## PLANNING DEPARTMENT STAFF REPORT AND FINDINGS

GAMBEE MINOR PARTITION – PRELIMINARY PARTITION APPROVAL (File MP 23–01)

### Preliminary Partition Plan Map

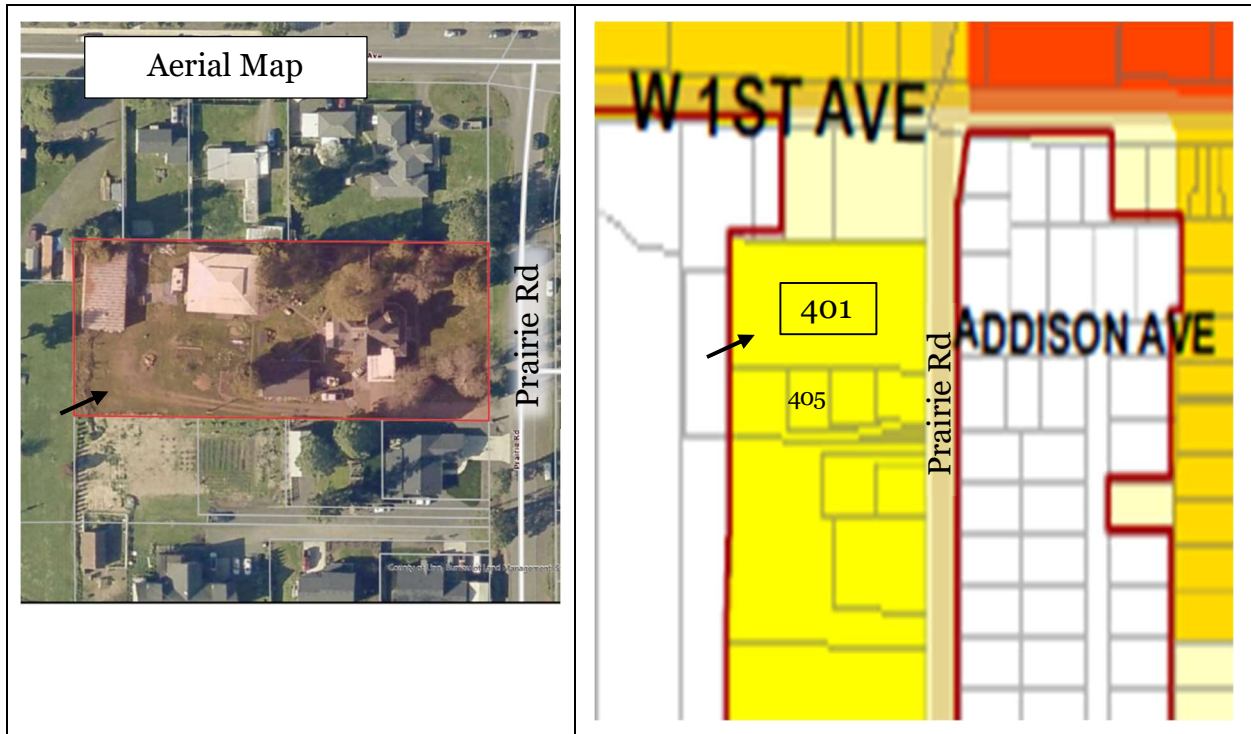
- **Junction City Fire & Rescue, Bob Trout**– The preliminary plan should provide the depth of the fire turnaround (on Parcel 3).
- **Lane County Transportation Engineering Services, Sasha Vartanian** – No comment at this time. Future development on the lots could trigger a TIA.

**Finding 6:** The preliminary plan does not have the entire dimensions of the parcels. The final plat must have this information.

**Finding 8:** The preliminary plan has the date, north point, and scale of the drawing. The dimensions of the property are adequately identified as adjacent tax lots are identified and numbers. A legal description of the subject property is included in the title report submitted with the preliminary plan. The assessor's account number (Act 1832508) is not depicted on the preliminary plan.

**Finding 9:** The name and address of the owner/partitioner is present on the preliminary plan but their telephone number is not. However, the telephone number is included on the application form. The applicant's representative's name and address is listed on the preliminary plan but no surveyor or engineer is identified on the plan or in supplemental material.

**Finding 10:** The preliminary plan shows Prairie Road and its right-of-way width. Addison Avenue is shown but its width is not.

**Finding 11:** The preliminary plan depicts the layout of the proposed parcels and their number. The complete dimension of each parcel is not included although their square footage, with and without the panhandle, is identified.

**Finding 12:** The preliminary plan shows the existing buildings on the property and their distance to the parcel lines, except for the shed and single-family residence on Parcel 1.

**Finding 13:** The preliminary plan shows that the panhandles are subject to an easement, but it does not label them as being either utility or access easements. The preliminary plan does not show the 5’ wide private utility easement that traverses the subject property nor the 10’ wide sidewalk and utility easement along the eastern perimeter of the subject property.

**Finding 18:** The width of the panhandles are identified as easements but are not specifically labeled as access or public utility easements. The 10’ sidewalk/public utility easement along the eastern perimeter of the subject property is not shown nor is the 5’ wide private utility easement that traverses the property.

**Finding 40:** The preliminary plan shows the 10' easement along the eastern border of the subject property and labels the panhandles as an easement. However, the plan should label these easements as to their purpose. Thus, the panhandle easement is for access and utilities. As that panhandle is no less than 15 feet in width this easement satisfies this criterion. Sewer and water lines are located at the property line but do not connect to the existing residence. Currently, no easement is for city water and sewer.

**Condition of Approval #1:** The final plat must show all easements. All easements must be recorded and the public utility easements dedicated to the City prior to final plat approval.

**Condition of Approval #3:** The panhandle shall have 15 feet of paving with a durable, dust-free surfacing of asphalt concrete, portland cement concrete or other approved material.

**Condition of Approval #5:** Parcels 2 and 3 shall have two parking spaces not located in the panhandle portion of the driveway and the turnaround area shall be of the dimensions shown on the preliminary plan.
